STAFF REPORT AND RECOMMENDATION TO THE DESIGN COMMISSION

CASE FILE: LU 16-111127 DZM AD
PC # 15-229299
SW 3rd & Salmon
REVIEW BY: Design Commission
WHEN: May 5, 2016 @ 1:30pm
WHERE: 1900 SW Fourth Ave., Room 2500A
Portland, OR 97201

3RD & SALMON / PORTLAND, OR
 FLOOR PLANS - LEVEL 1 C.21

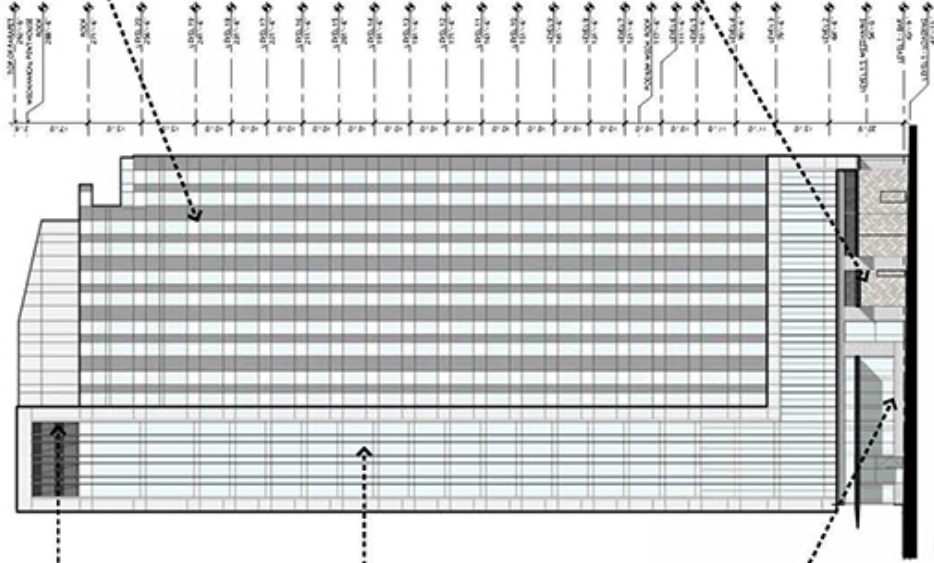
restaurant is expected to occupy the space. This will provide the opportunity for activity to easily flow between the interior and exterior, contributing to a vibrant streetscape experience. Staff notes, however, that there appears to be inconsistencies in the drawings as some drawings (enlarged elevation – C.64) imply that there will be no physical barrier at the west operable storefront while other drawings (nighttime rendering – C.73) imply that there is a stem wall. This should be clarified. Staff also notes that the enlarged elevations of the west façade, shown on C.58 and C.64, do not match with regard to the location of glazing and columns, however, staff believes that C.64 is the intended condition as this most resembles the ground floor plan on C.21. This should also be clarified.

3RD & SALMON / PORTLAND, OR
C.50 ELEVATIONS - EAST - SW 2ND

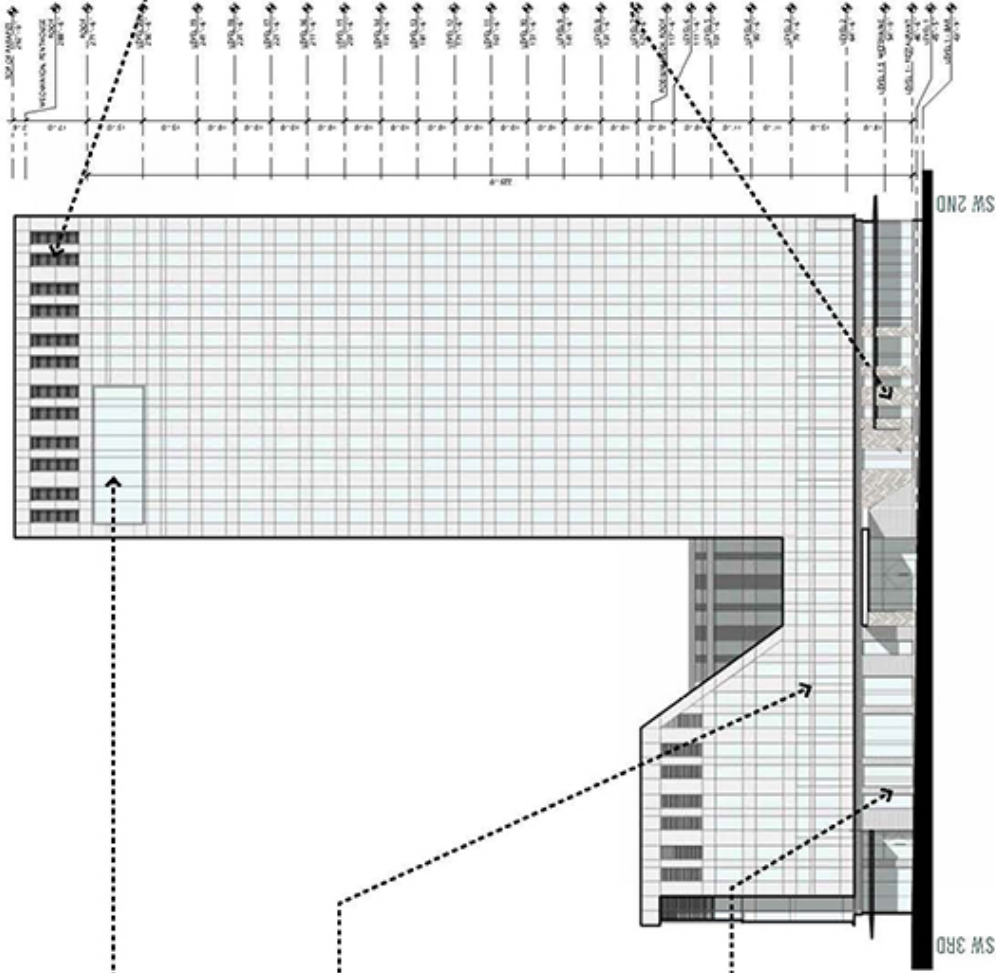
On the east façade, however, the applicant is requesting a Modification to the ground floor windows standard to reduce the total length of windows from 50% to 43%. This reduction is requested because the loading stall, trash area, and two exit stairs are located in this area. The applicant proposes laser-cut metal screening to be applied to the east wall, some of which is proposed to be back-lit, in order to add interest where windows are lacking; this screen is also applied elsewhere on the building in similar instances. While the loading area and one exit passage are required to connect directly to the street frontage, the trash area could potentially be shifted so that it does not front on the street. Staff also notes that as currently designed, the transformer vault is proposed to be located in the basement with an access hatch located adjacent to the loading space. While this proposal has not been, to staff's knowledge, approved by PGE, staff notes that the proposed design results in additional area of opaque façade at the street frontage and is therefore less desirable than another solution which will not affect the building's exterior. In addition, staff notes that the two exit passages seem to be redundant and suggests that these should be consolidated in order to expand the bar/market space to the north. This may result in an increase of glazing and perhaps elimination of the requested Modification.

Findings: As is noted above, the design proposes to locate the loading area and back of house uses at the northeast corner. While staff supports the concentration of such uses in theory, the proposed design requires additional consideration. Staff has noted above that, in addition, to the loading area and an egress which are required to be located at the street frontage, the trash area is also located along the street frontage. The applicant also proposes to locate the utility vault access hatch within the loading bay, to the north of the loading space. To staff’s knowledge, PGE has not agreed to this location and staff notes that the vault’s location, as currently

designed, results in additional opaque wall area at the street frontage. In addition, the applicant proposes two separate egress corridors, which could be consolidated for a true speakeasy experience while also allowing greater expansion of the southeastern bar/market space. While the applicant proposes a laser-cut metal screen to be attached to the exterior of the building as mitigation for the lack of windows, staff does not believe that either the purpose of the standard is met nor are guidelines better met by the proposed design.

This guideline is not met. With additional consideration of the program at the northeast corner of the building and the introduction of additional glazing, this guideline may be met.

3RD & SALMON / PORTLAND, OR
 ELEVATIONS - SOUTH - SW SALMON C.51

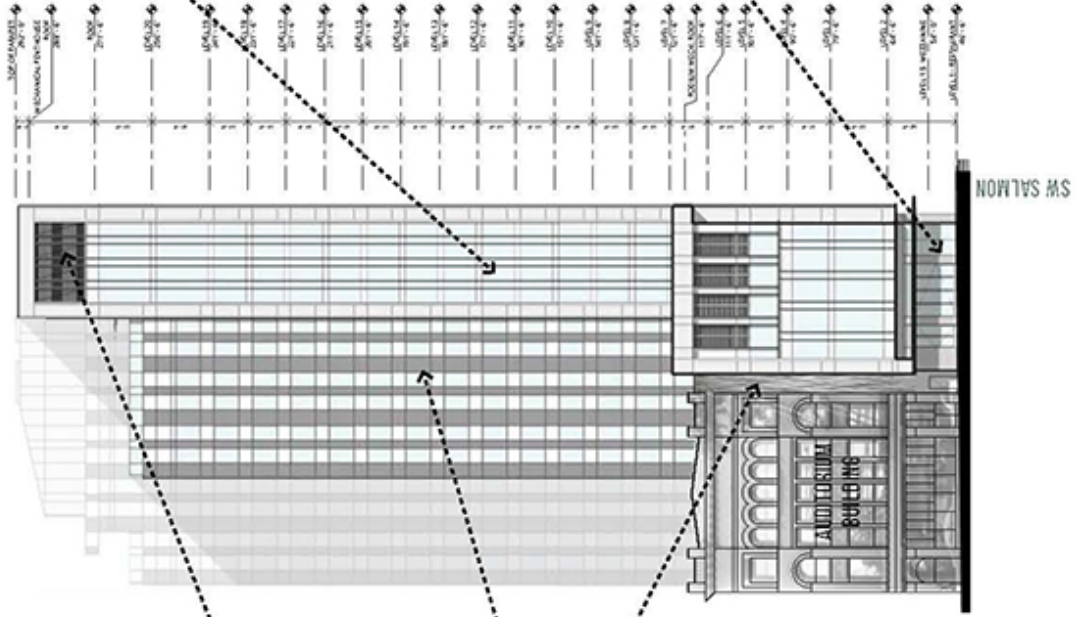
At the November 19, 2015 Design Advice Request, the Design commission noted that the tower was relatively small and, as such, did not require multiple façade expressions. Staff notes that the tower has three distinct façade articulations, two of which are continued at the western volume. The proposed vertical frame at the south end of the tower responds to the south setback of the World Trade Center building and therefore adds a certain logic to the articulation of this façade. Staff has concerns however with the overall flatness and repetitiveness of the south façade, including where it continues to the western volume. As such, staff suggests that greater cohesion is needed for the overall façade, with additional consideration toward adding texture and breaking up the repetitive form of the south façade.

These guidelines are not met. With the provision of additional details for the laser-cut metal screen, and consideration of the scale, form, and materiality of the western volume and greater cohesion of the tower volume with additional consideration of the flatness and repetitiveness of the south façade, these guidelines may be met.
